**CERTIFICATE OF APPROPRIATENESS**

TAX MAP N°: 55 PARCEL N°: 555  
Street & Number of Proposed Work: 8 NICLANOOSE WAY  
Owner of record: DENNIS J. MEEHAN  
Mailing Address: 37 SYLVAN WAY  
TUXEED PARK, NY 10987  
Contact Phone #: \_\_\_\_\_ E-mail: \_\_\_\_\_

- New Dwelling  Addition  Garage  Driveway/Apron  Commercial  Historical Renovation  Deck/Patio  Steps  Shed
- Color Change  Fence  Gate  Hardscaping  Move Building  Demolition  Revisions to previous Cert. No. 63197
- Pool (Zoning District \_\_\_\_\_)  Roof  Other \_\_\_\_\_

**Meehan Residence**  
**Eight Nickanoose Way**  
~ Nantucket ~

RENOVATED EAST ELEVATION

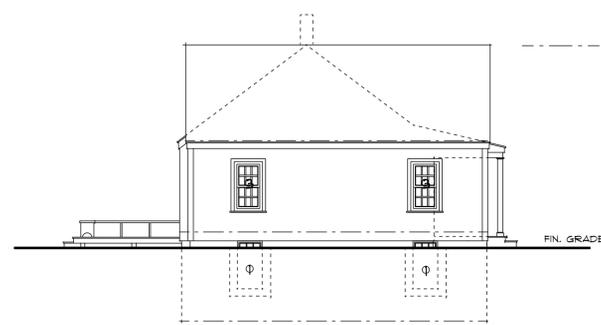
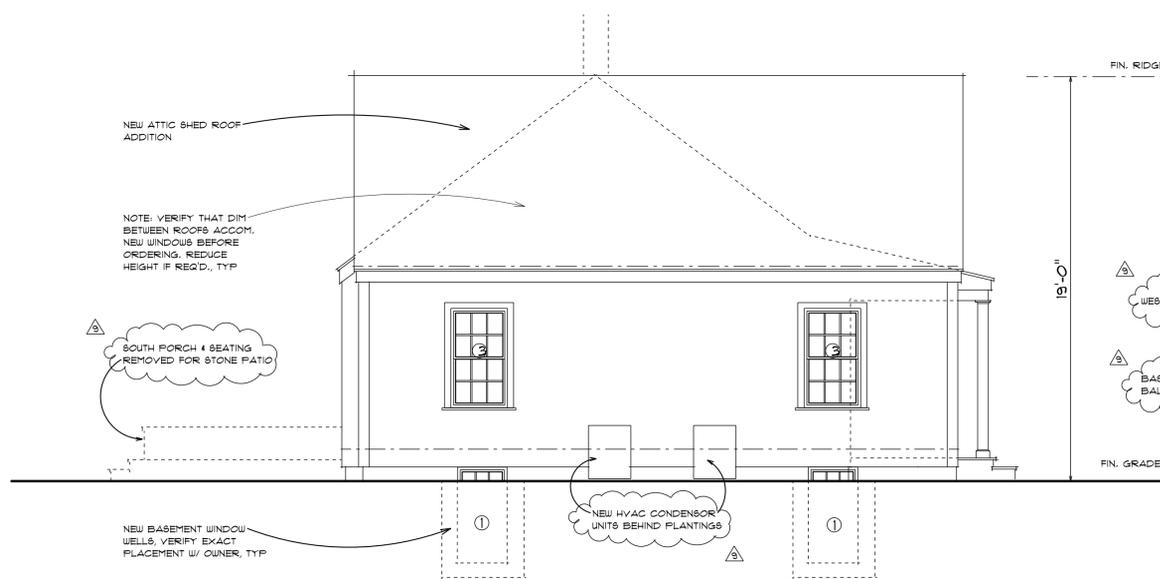
1. East Elevation ; Add HVAC Condensor units
  2. South Elevation ; Deck & Seating removed for bluestone patio
  3. West Elevation ; West porch removed, basement stair balustrade exposed (24' long)
  4. North Elevation ; West porch removed, basement stair balustrade exposed
- \*Cloud on drawings and submit photographs of existing elevations.
